**ELST Inglewood Hill Parking Lot
SSDP2016-00414**

**Shoreline Substantial
Development Permit Hearing
Jan. 24, 25, & 26, 2018**

ELST Inglewood Hill Parking Lot - SSDP2016-00414

TREE PRESERVATION PLAN EXHIBIT
 FILE NUMBER SSDP2016-00414

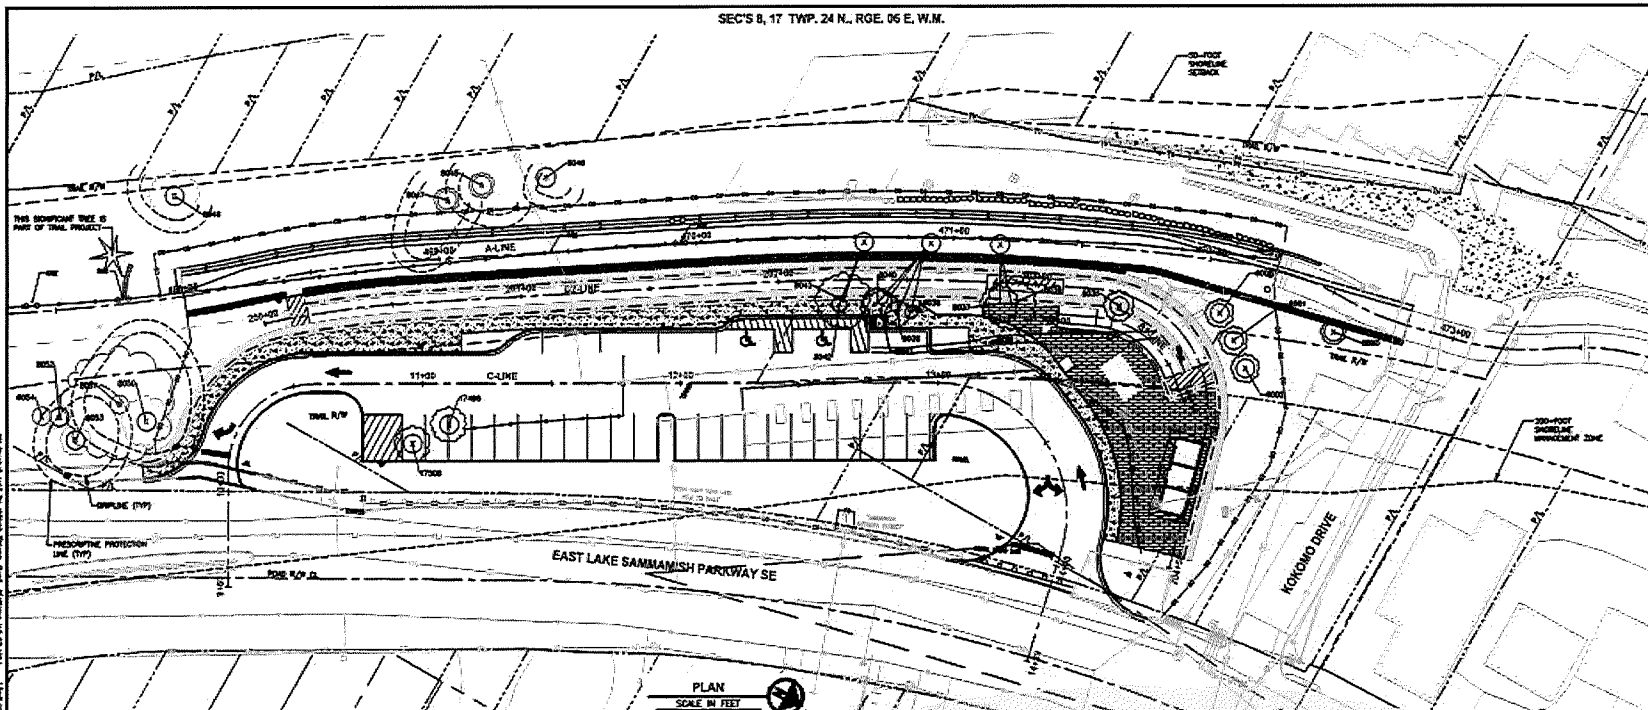
Tree Preservation

- SMC 21A.37.230 – Removal and Retention Exemptions
 - Replacement is still required pursuant to SMC 21A.37.280 “Tree Replacement Standards”
- SMC 21A.37.270(5) & (7) – Prescriptive requirements and Alternative Measures

NOTE: IMPLEMENTATION OF PRESCRIPTIVE TREE PROTECTION (RECOMMENDED CONDITION OF APPROVAL #6) RESULTS IN LOSS OF 4 ADDITIONAL TREES
